# Staff Report

**Item:** DR 24-05, "Covers for Play Structure & Outdoor Event Area" at Nuevo Amanecer Apartments, 1274 N. 5th St

# Analyses & Findings

Figure 3.01B – Major Arterial

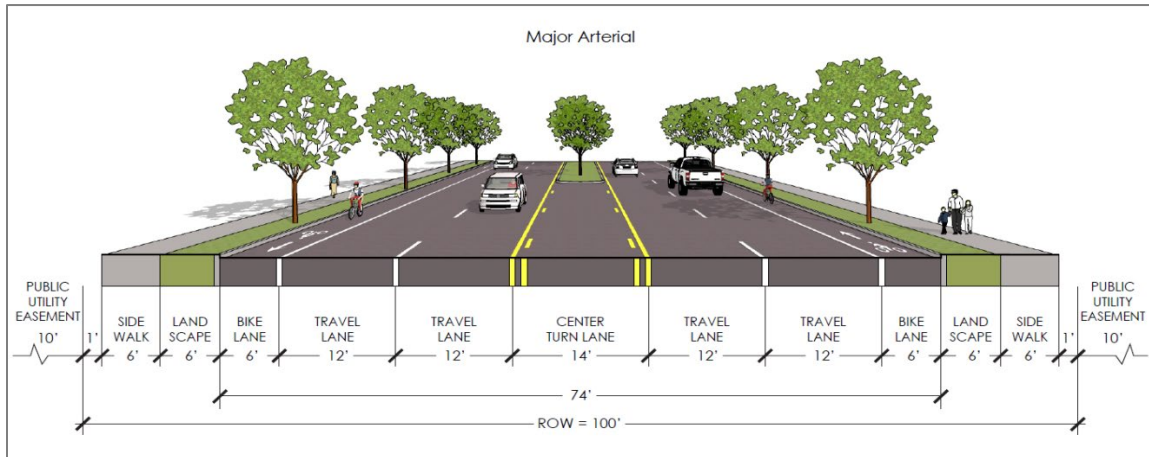
The subject property has frontage along Hwy 214/Mt Hood Ave. which TSP Figure 2 illustrates is a major arterial street. The default cross-section for major arterial streets is Figure 3.01B. Existing conditions of Mt Hood Avenue along the property include:

- Approximately 77 feet of right-of-way, while the cross-section calls for 100’.
- Public Utility Easement (PUE): 15’
- Curb and drainage facilities;
- Bike lane; and
- A curbtight sidewalk with landscape strip behind it.

The proposal is a development and therefore the standards within 3.01 would typically apply, however, after an analysis of the nexus of proportionality, the Director determined that most of

the street improvements were not a proportional exaction compared to the scale of the proposed project.

Dedicating a 5' Public Utility Easement (PUE) is the only street improvement the applicant is required to make.

Figure 3.01E – Access Street / Commercial Street

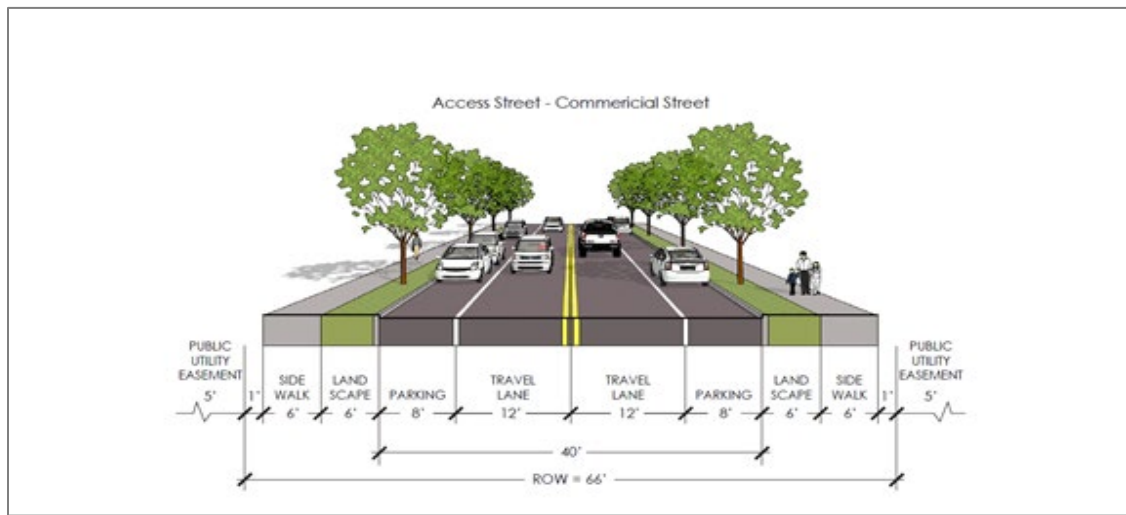
The subject property also has frontage along N 5<sup>th</sup> St. which TSP Figure 2 illustrates is an Access/Commercial Street. The default cross-section for an Access Street / Commercial Street is Figure 3.01E. Existing conditions of N 5<sup>th</sup> St. along the property include:

- Approximately 60 feet of right-of-way, while the cross-section calls for 66’.
- PUE: none recorded
- Curb and drainage facilities; and
- A curbtight sidewalk with a landscape strip behind it.

City records do not indicate an existing streetside public utility easement along N 5<sup>th</sup> St. Figure 3.01E requires a 5-foot streetside public utility easement along Access Streets, therefore staff adds *Condition of Approval 1* to grant this easement.

- D2. Streetside PUE: To meet 3.01.04 and 3.02.01B, grant a 5-foot streetside public utility easement (PUE) along the frontage of 5<sup>th</sup> Street. This easement must be recorded prior to building permit final inspection. Work with Public Works to finalize this process.
